Planning Applications Committee

26 April 2023

Modifications Sheet.

ITEM 5 (WIM CHASE STATION, KINGSTON ROAD & 45 – 48 ROTHESAY AVENUE, RAYNES PARK, SW20 8JT)

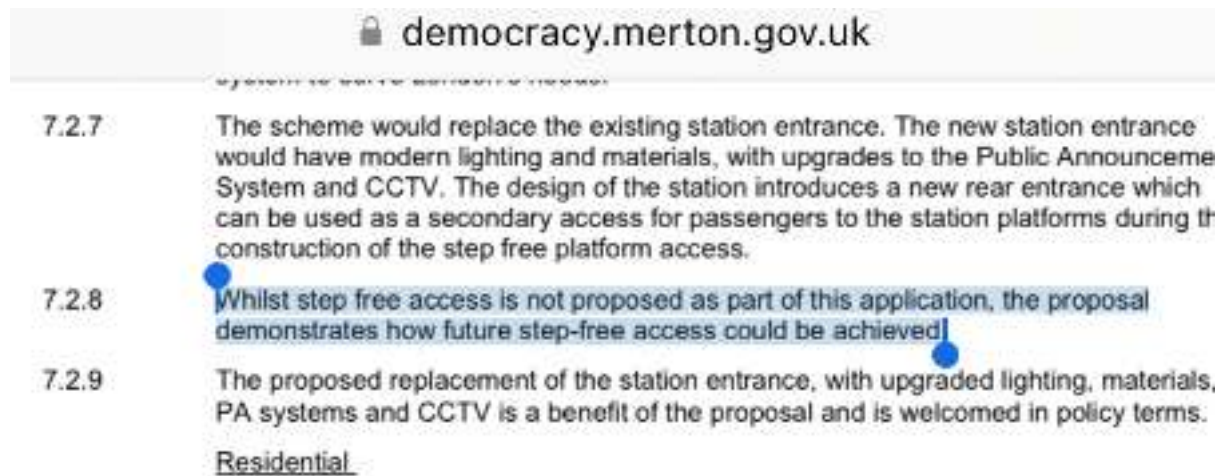
The four options in the feasibility study have been rejected by the railway companies and there has been no demonstrable investigation of the “safeguarded” 5th option.

I attach some photos of proposed tunnel location since there are none in any of the documents.

The proposed development does not purport to provide step free access. A method by which step free access could be provided is suitably safeguarded by the proposed development as the main passenger concourse would be adjacent to the location where the tunnel would be created whereas currently it is adjacent to back of house facilities. Therefore, the proposal would allow for future step free access. At such time that step free access is proposed then further applications may be required. However, this does not affect the planning merits of this application, which should be considered on the basis of not providing step free access, but allowing for it in the future.

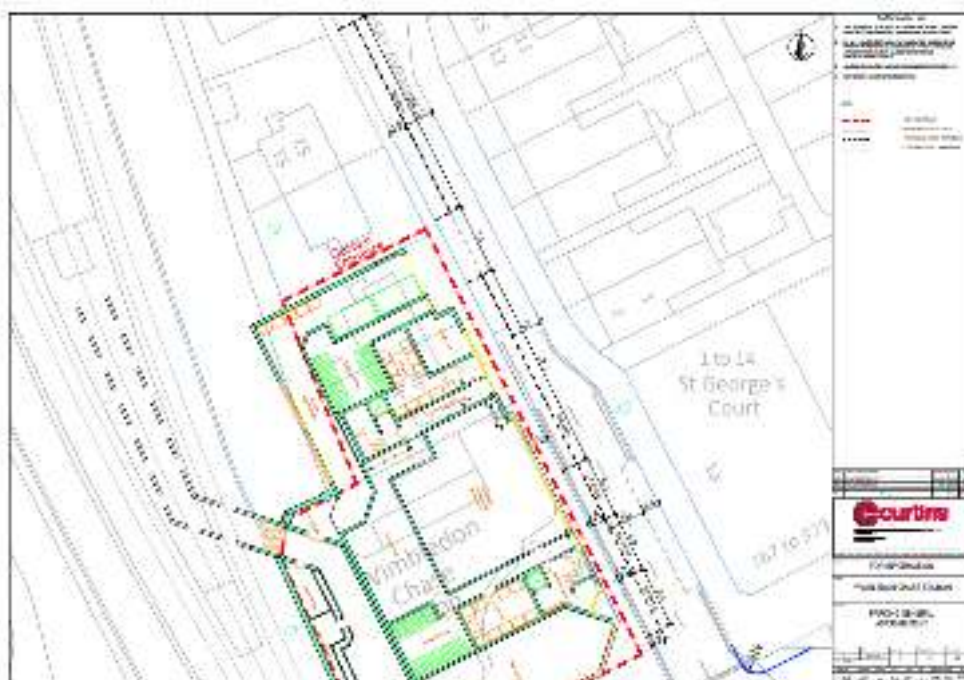
- With regards to the proposed loading bay on Kingston Road, it is proposed to introduce a buildout at the Rothesay Avenue/Kingston Road junction to mirror that at the Sandringham Avenue/Kingston Road junction.

- The proximity of the loading bay to the side road and the visibility for vehicles exiting the side road, would be exactly the same as the arrangement at Sandringham Avenue. The applicant has commissioned an independent Stage 1 Road Safety Audit for the proposed loading bay and no safety issues were raised with regards to the visibility for vehicles exiting Rothesay Avenue. Historical road accident data at the Sandringham Avenue/Kingston Road junction has also been interrogated and no significant correlations have been identified in the data that suggests the existing arrangement at Sandringham Avenue is unsafe.

- No evidence has been presented to demonstrate that existing arrangement at the Sandringham Avenue/Kingston Road junction is unsafe. We are also not aware any plans to change the existing arrangement.

The servicing requirements for the proposed units would be limited due to its modest size. The scheme would not result in the overall loss of any parking bays. If concerns remain in relation to the proposed loading bay it would be entirely feasible for the development to utilise the existing loading bay. This would allow for the retention of a further two on-street parking bays on Kingston Road.

Officers advise that a revised servicing plan could be secured by way of condition, to be discharged in conjunction with the Council's Transport Planner and Highway Authority, along with TfL if necessary.

Proposed model:

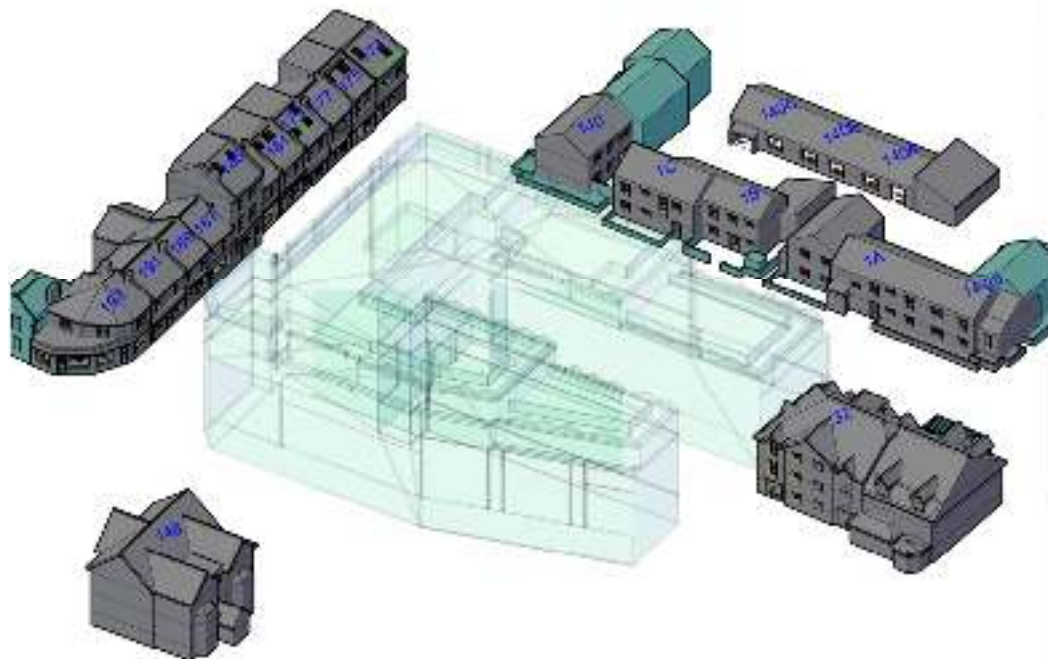
Agent comment on daylight/sunlight:

Any meaningful development on the Site will have some degree of inevitable impact on Daylight & Sunlight, but the results of the Daylight & Sunlight Analysis show that the height and massing of the proposed scheme will leave all of windows serving habitable rooms in the neighbouring dwellings, with adequate, and in most cases, good residual levels of daylight and sunlight. Given the location and character of the Site within the borough, and London in general, absolute residual readings of daylight around mid-teens VSC values is an appropriate threshold of daylight to be expected and in this development, all habitable rooms in all the neighbouring dwellings will continue to receive natural daylight levels above this level confirming that adequate daylight will continue to be received.
